LEE'S SUMMIT
MISSOURI
Development Services Department

Development Services Staff Report

File Number	PL2022-178 – PRELIMINARY DEVELOPMENT PLAN – McBee's Coffee N Carwash
Applicant	McBee Construction Company
Location	1295 SW Arborwalk Blvd.
Planning Commission Date Heard by	July 14, 2022 Planning Commission and City Council
Analyst	C. Shannon McGuire, Planner
Checked By	Hector Soto, Jr., AICP, Senior Planner Kent Monter, PE, Development Engineering Manager

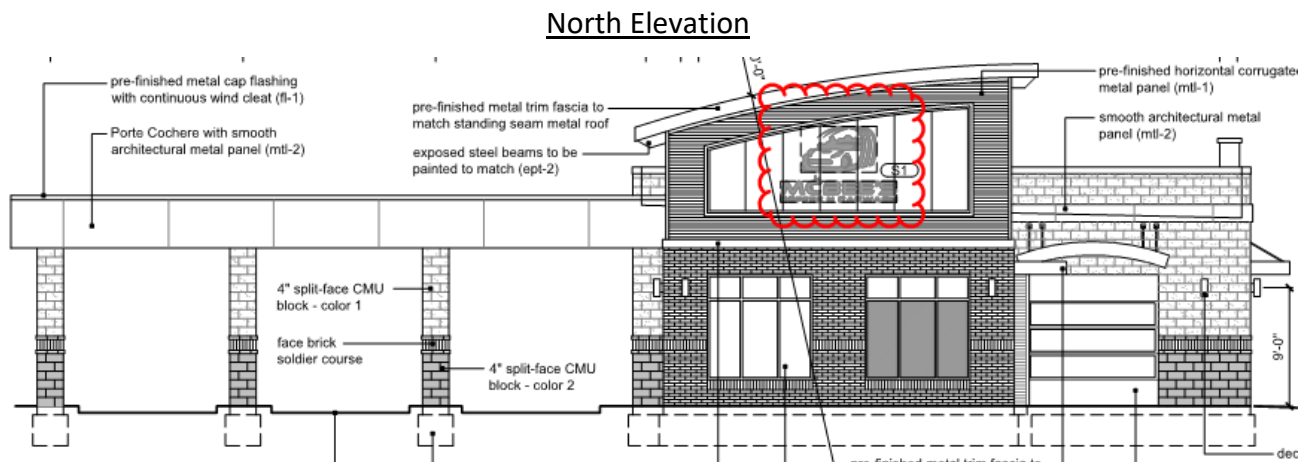
The proposed development will not detrimentally impact the surrounding area. The proposed project develops a long-vacant property. The proposed development's southeast access point does not comply with the City's Access Management Code (AMC). The proposed Driveway 1 is designed to provide approximately a 50-foot throat length from MO-150. According to the AMC, the necessary throat length for this location is 100 feet. The applicant has proposed an alternate location (slightly north) which staff does support. The development is not expected to create an excessive amount of stormwater runoff. Underground detention will be employed for stormwater management.

1. Seven (7) total attached wall signs shall be approved as shown on the Exterior Elevations dated May 13, 2022 and revised June 14, 2022.
2. Driveway 1 shall be located slightly north of the originally proposed location, as shown on the alternate design on Sheet A1.1, in order to meet the throat length (100 ft) requirement of the Access Management Code.
3. Development shall be in accordance with the preliminary development plan dated May 13, 2022 and revised June 14, 2022.

South Elevation

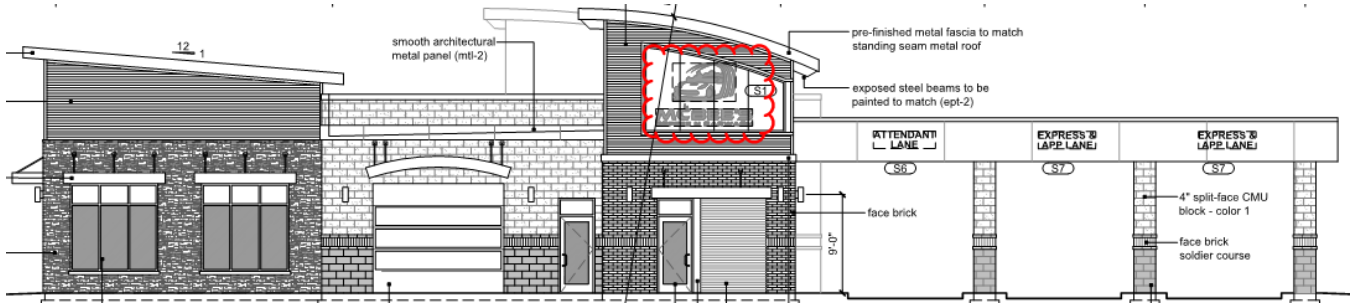
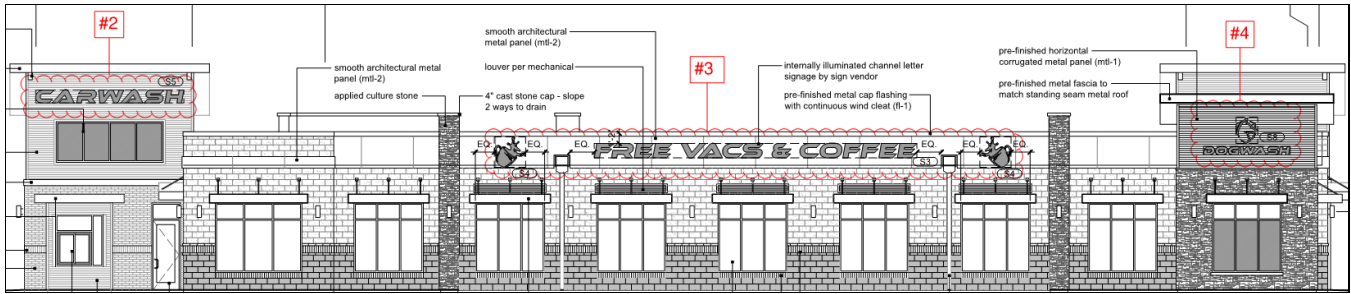
Additional Wall Sign Request.

- **Required** – A single tenant building is allowed 3 walls signs.
- **Proposed** – The applicant has 7 total wall signs as shown on the Exterior Elevations, dated May 13, 2022 and revised June 14, 2022

- **Recommendation** – The request for additional wall signage is not out of place for this type of commercial business. Many restaurants and retailers have more than the number of signs allowed by right. In this case, the subject site will have traffic circulation around three sides of the building with visibility to MO 150 Hwy on the east, south and west sides of the building. The north façade will be visible to SW Arborwalk Blvd. Of the seven sign four signs will advertise the services offered, the remaining three signs function to identify and direct customers to the appropriate services lanes. Staff believes the proposed seven wall signs are compatible for the area, proportional for the building and provides a reasonable means of identification for the tenant space.
